**OPERATIONAL QUALITY ASSURANCE PROGRAM DESCRIPTION
PROPOSED REVISION 29, SUMMARY OF CHANGES**

ATTACHMENT 1

FIGURE 1-1

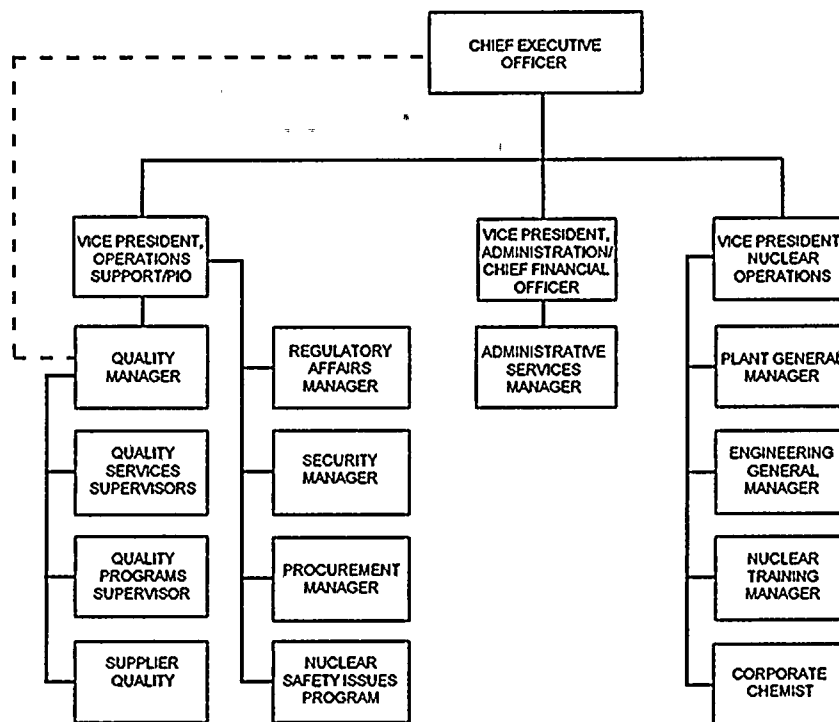
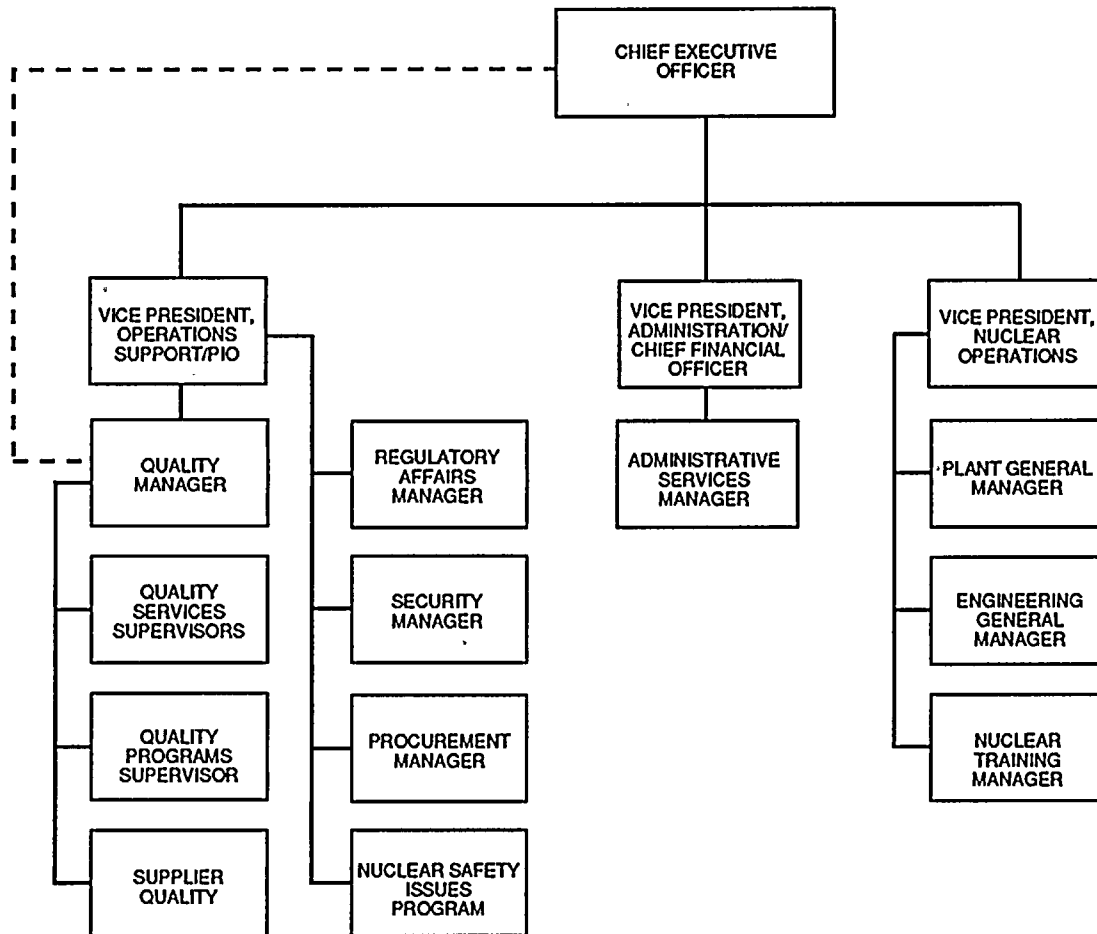
Figure 1-1 was revised to eliminate the position of Corporate Chemist.

FIGURE 1-2

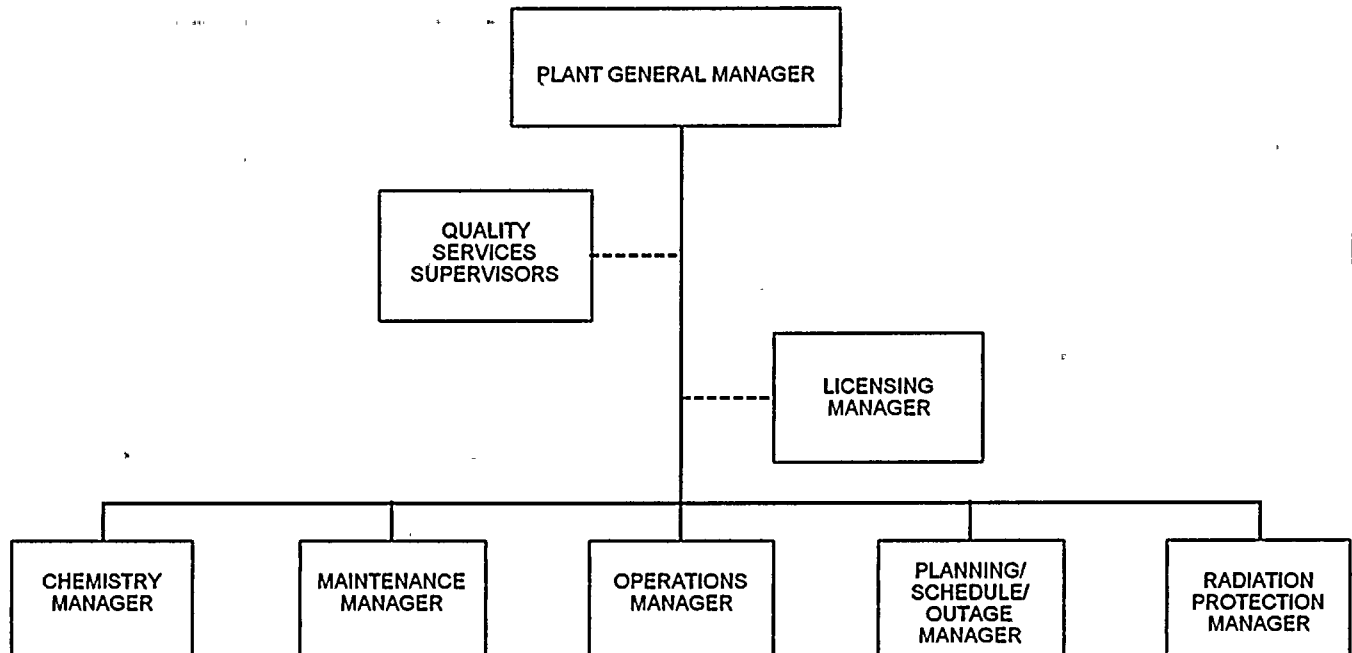
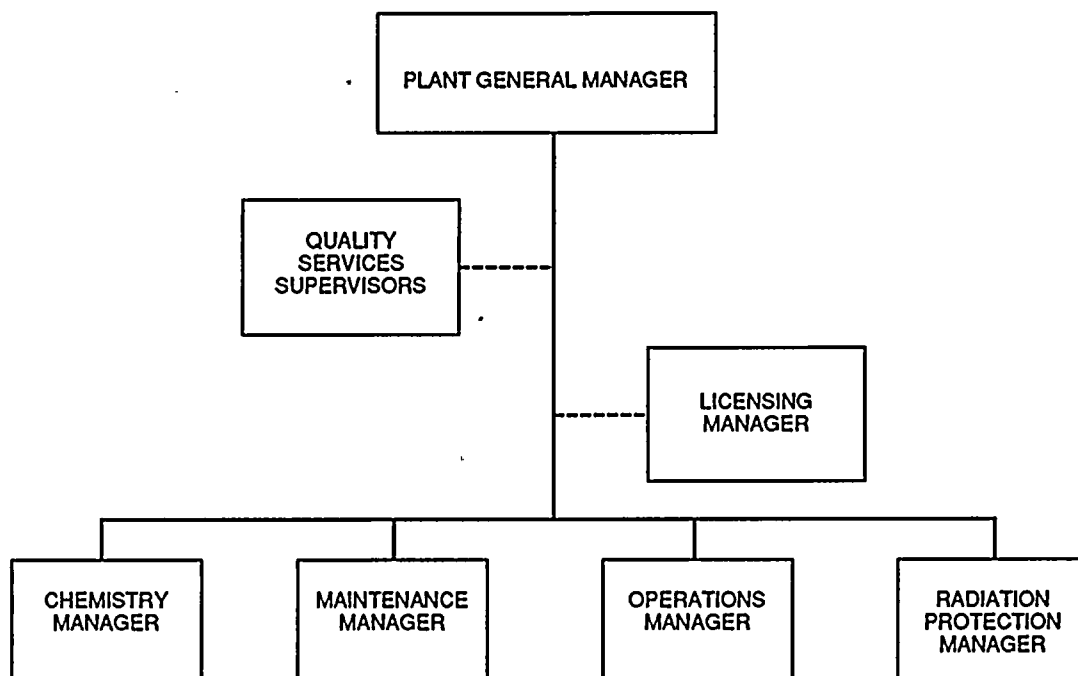
Figure 1-2 was revised to eliminate the position of Planning/Scheduling/Outage Manager.
